client
SKC Projects
project
11A Lyndhurst Road
title
Existing & Proposed Plans

date
May '24
drawing no
037-100 rev 04

Proposed Ground Floor Plan 1:50@A1

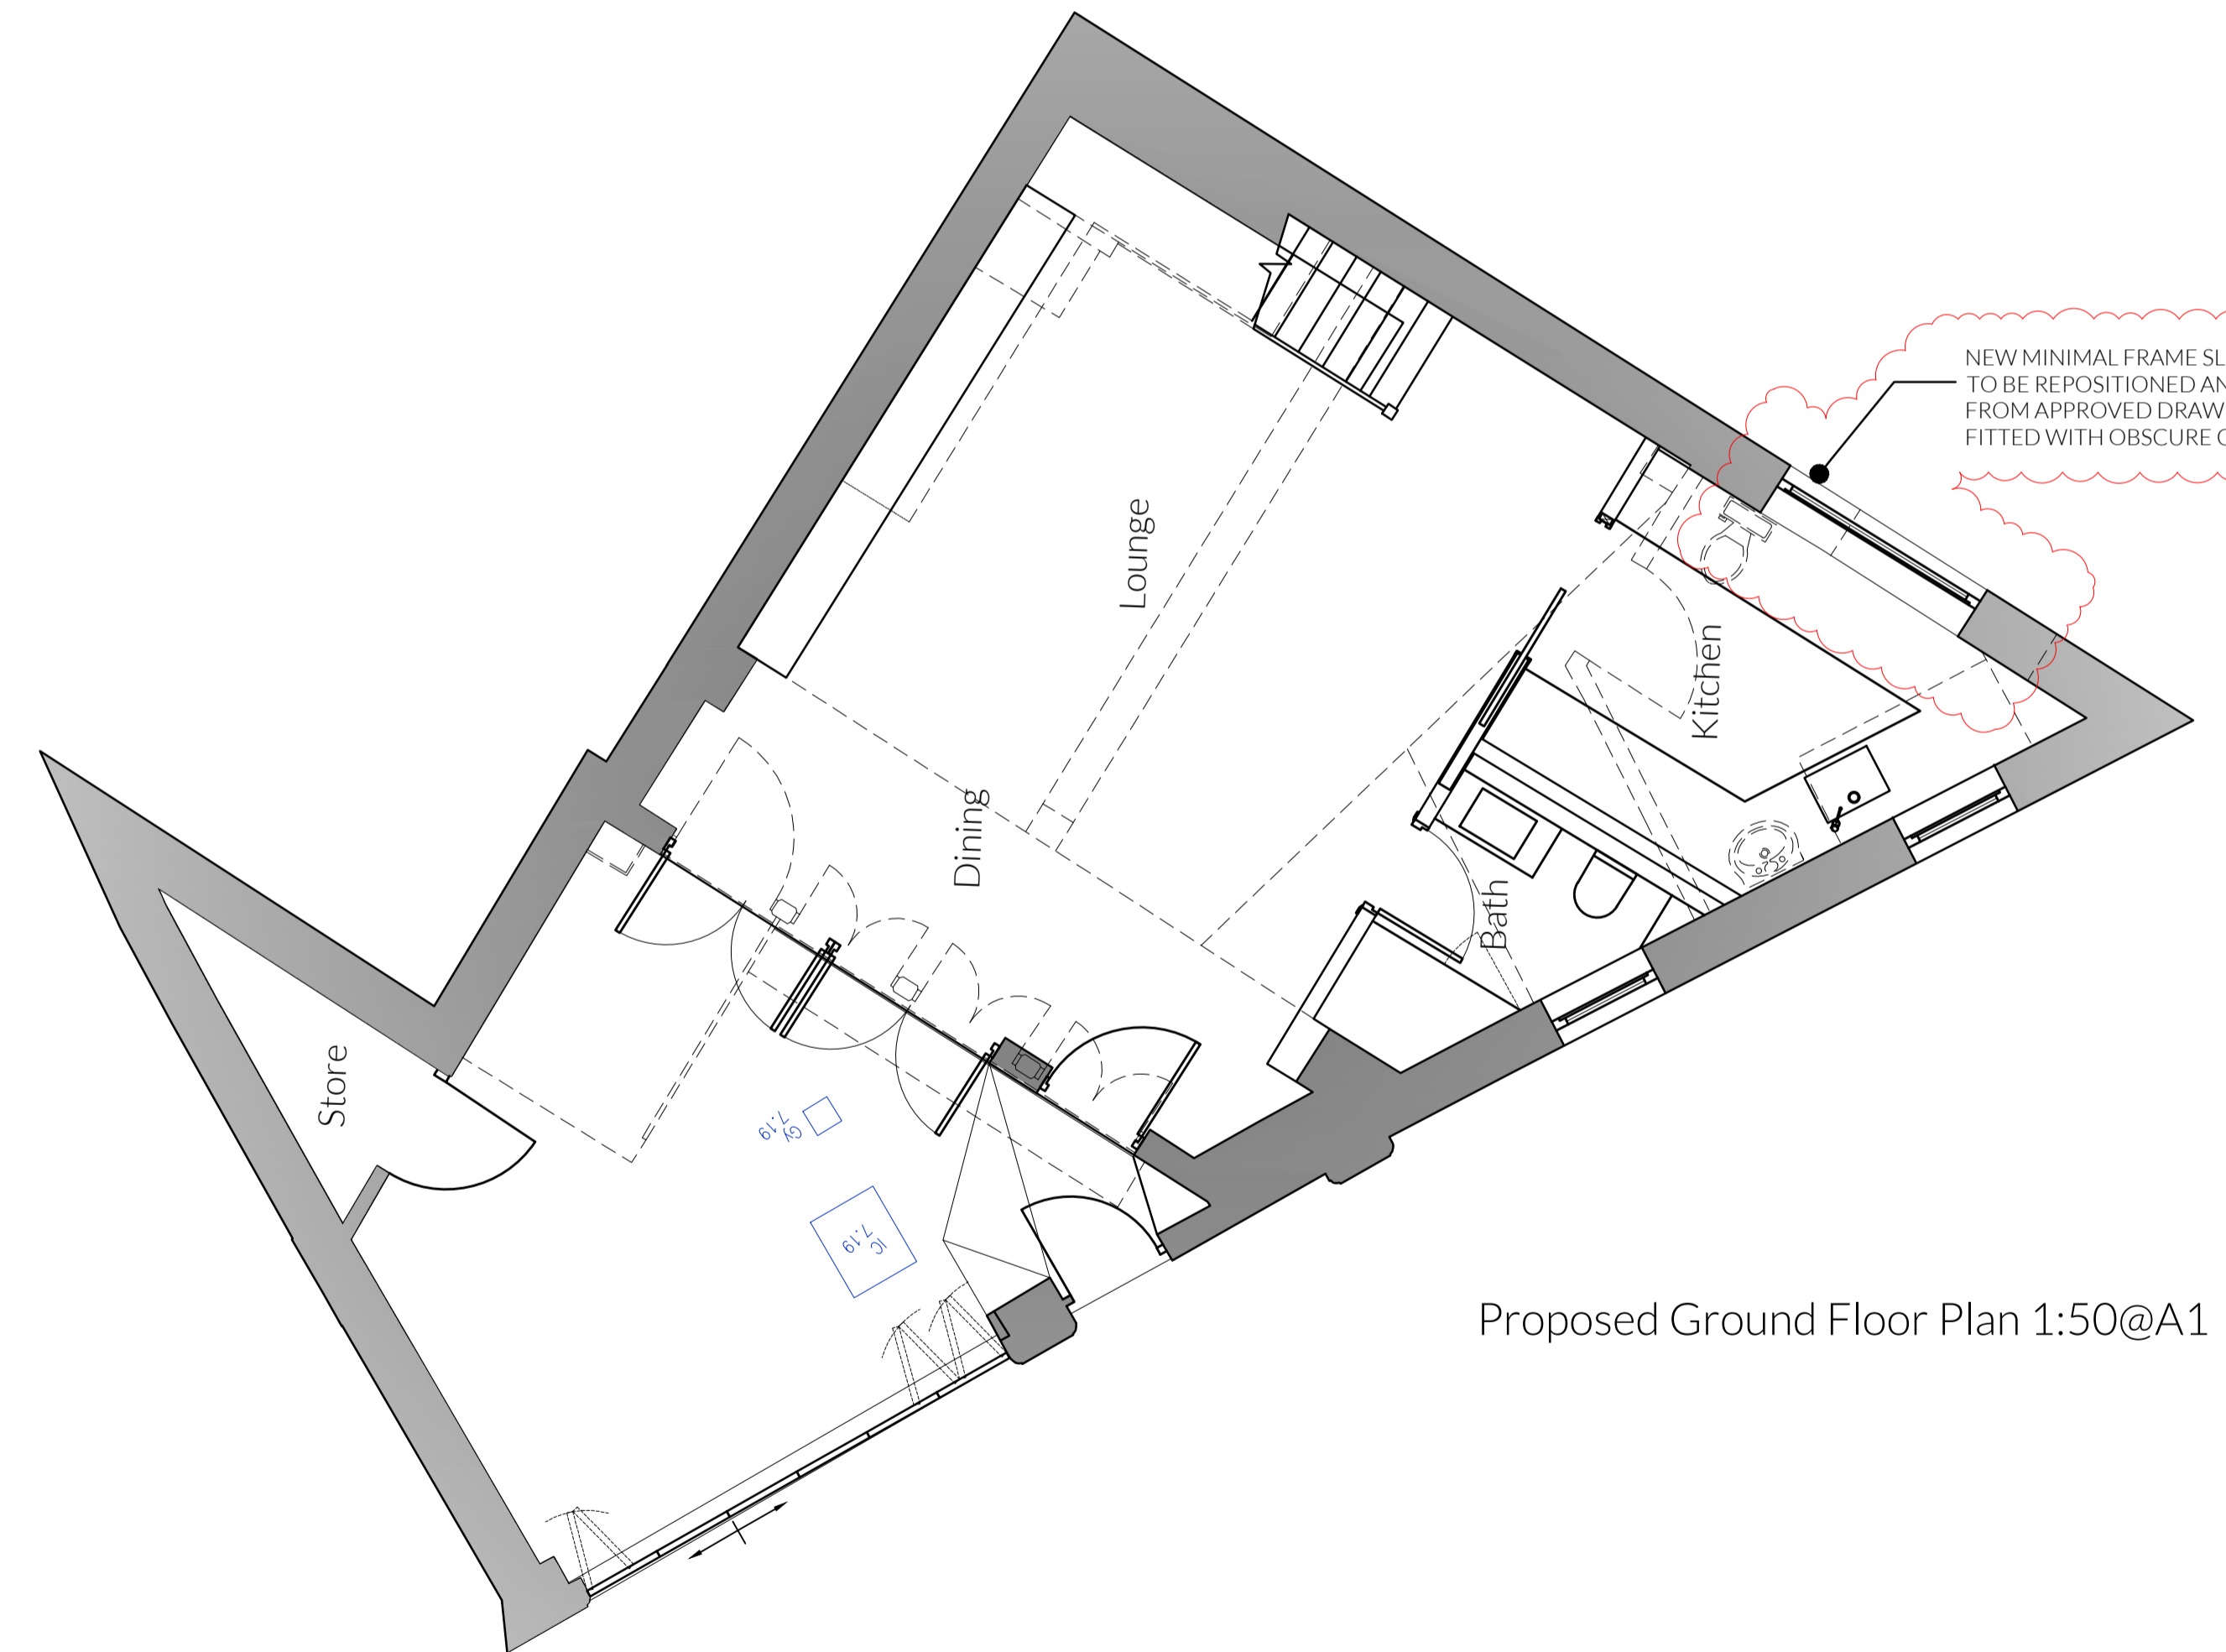
NEW MINIMAL FRAME SLOT WINDOW
TO BE REPOSITIONED AND RE-SIZED
FROM APPROVED DRAWING. TO BE
FITTED WITH OBSCURE GLAZING.
